CE 272-07 Carpenters Point Wastewater Consistency Report System

Re: Carpenter's Point Wastewater Collection

Re: Carpenters Point Wastewater Collection System, Phase 2
Chesapeake Bay Critical Area Consistency Report

Re: Carpenter's Point Wastewater Collection System Phase II

COLLECTION SYSTEM EROSION AND SEDIMENT CONTROL PLAN NO. 4

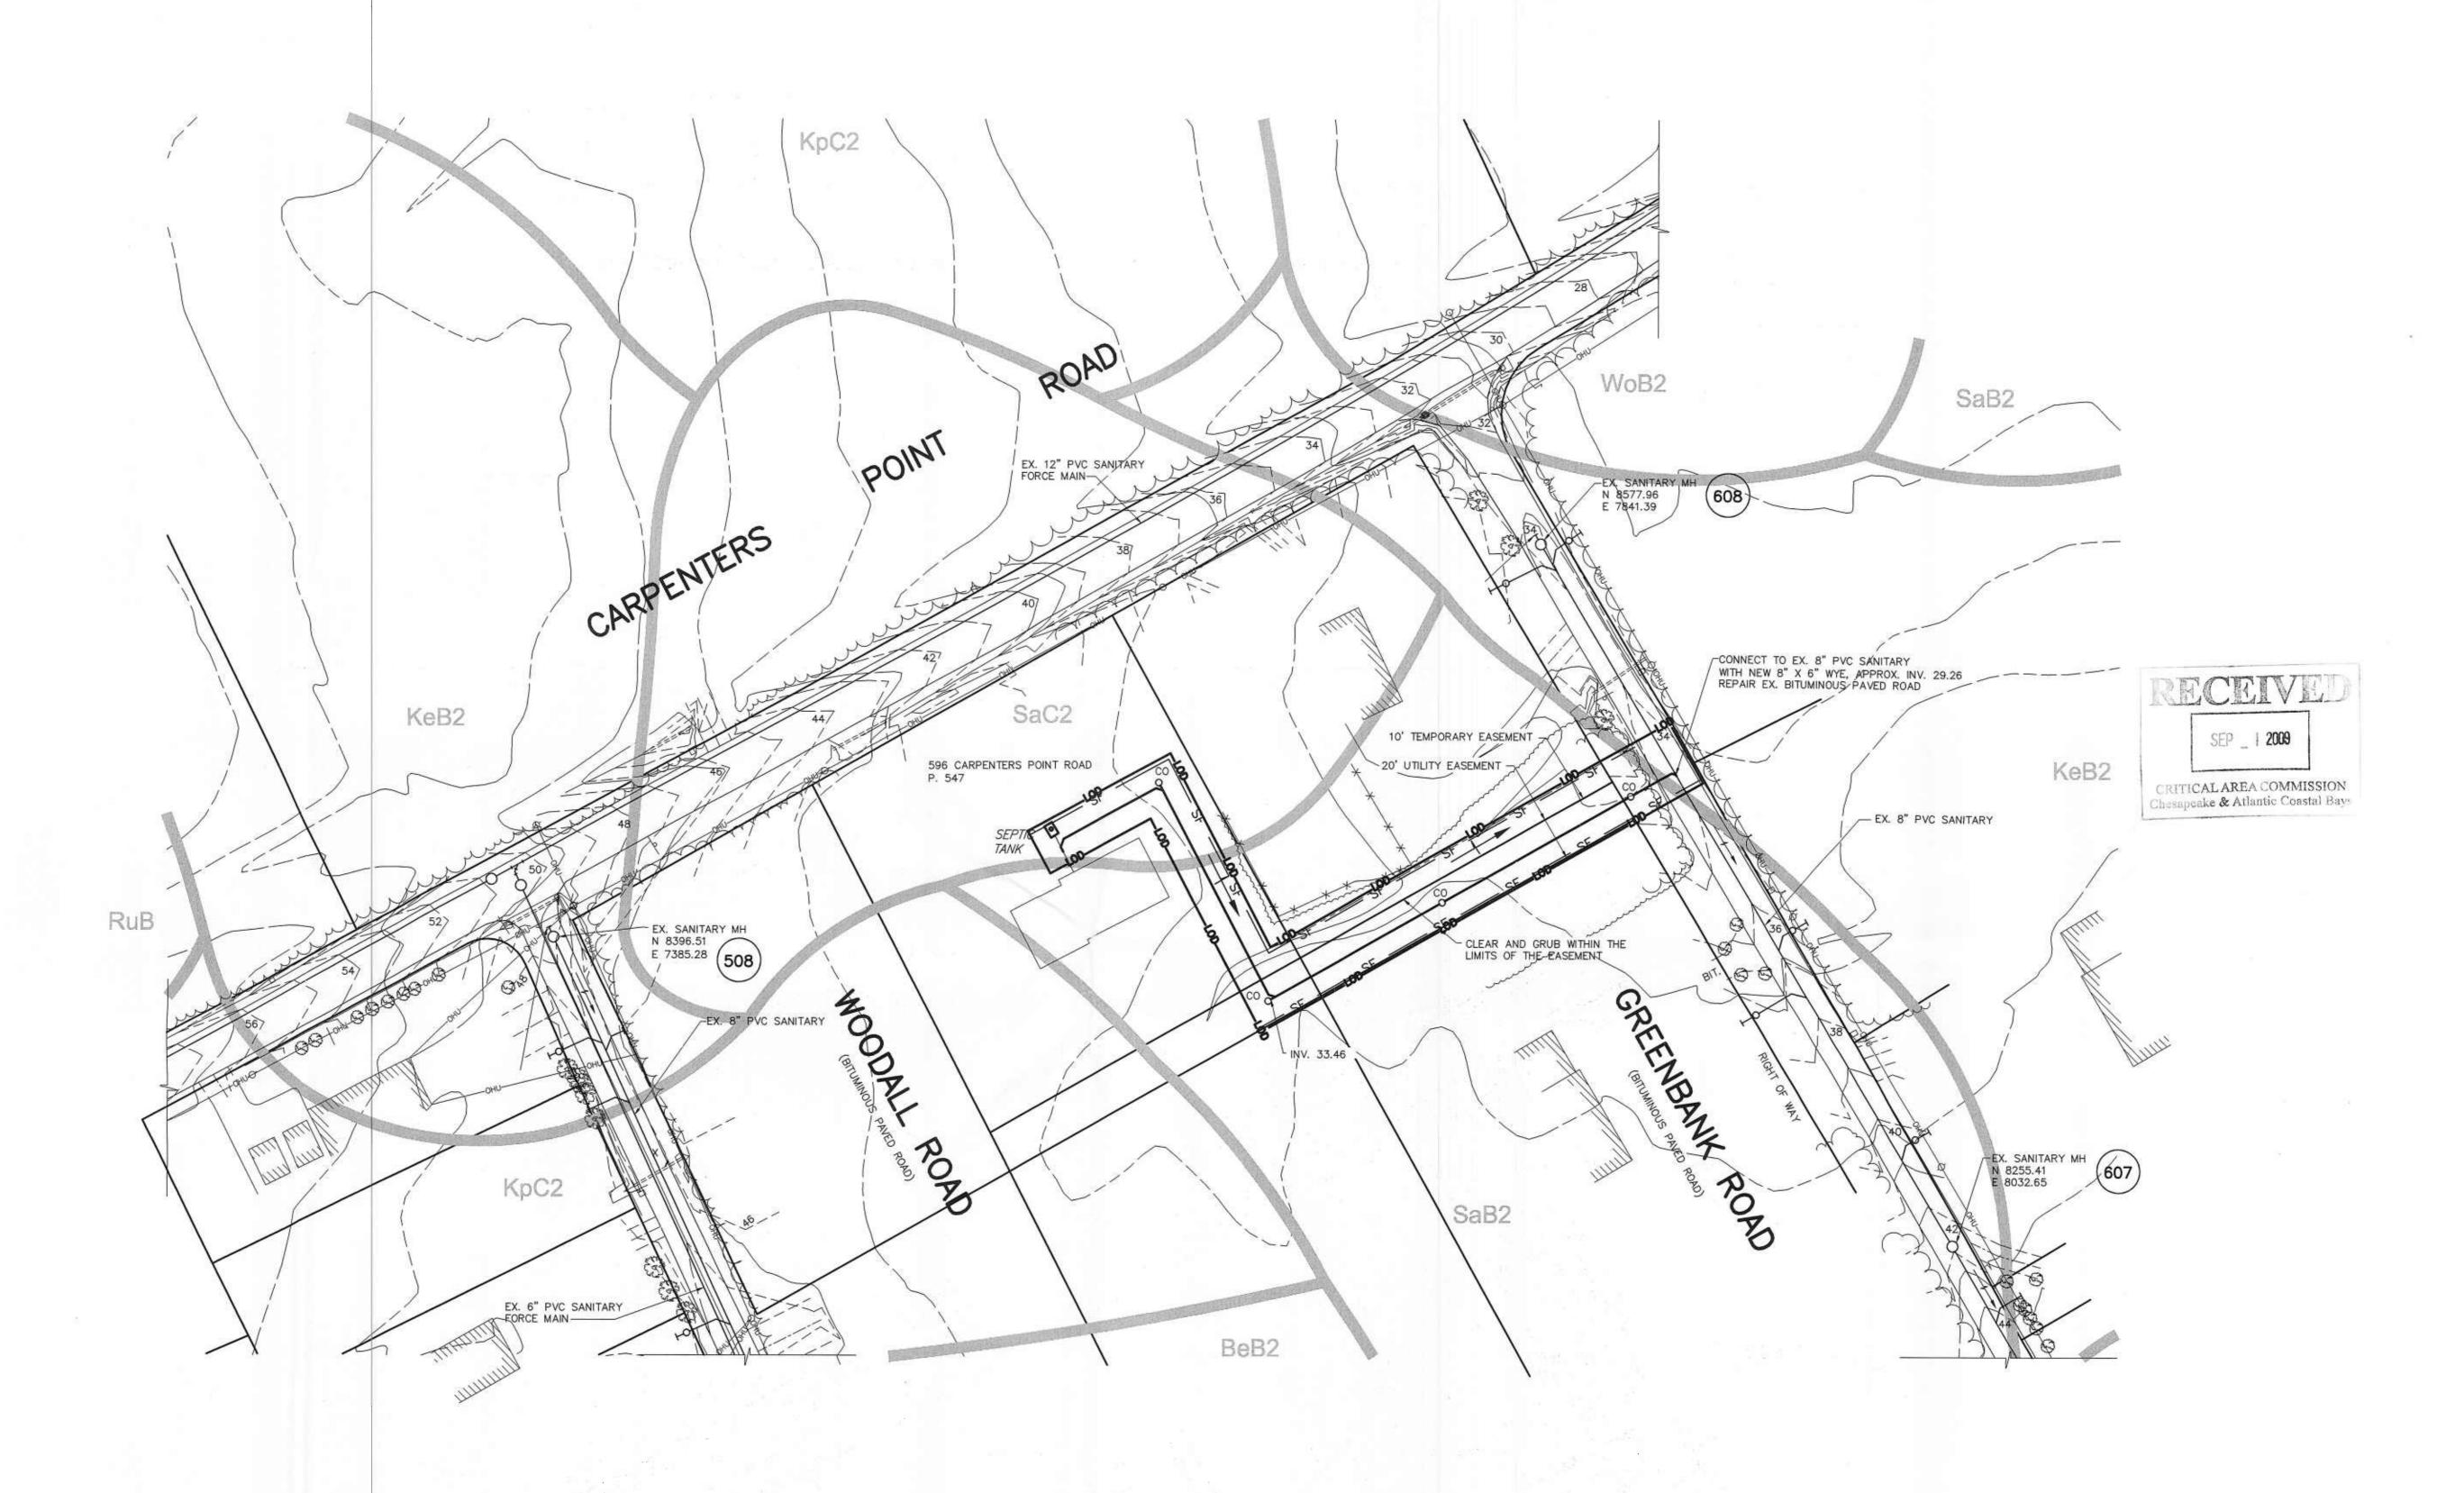
• Since 41,894 square feet (21.8%) of clearing is proposed on the site, mitigation at a 1.5:1 ratio is required (62,841 square feet). Currently, only 1:1 mitigation is proposed. Mitigation in the form of tree plantings would be acceptable and should consist of a mix of native trees and shrubs Furthermore, a site plan showing the location and species of mitigation is required along with the submitted planting plan.
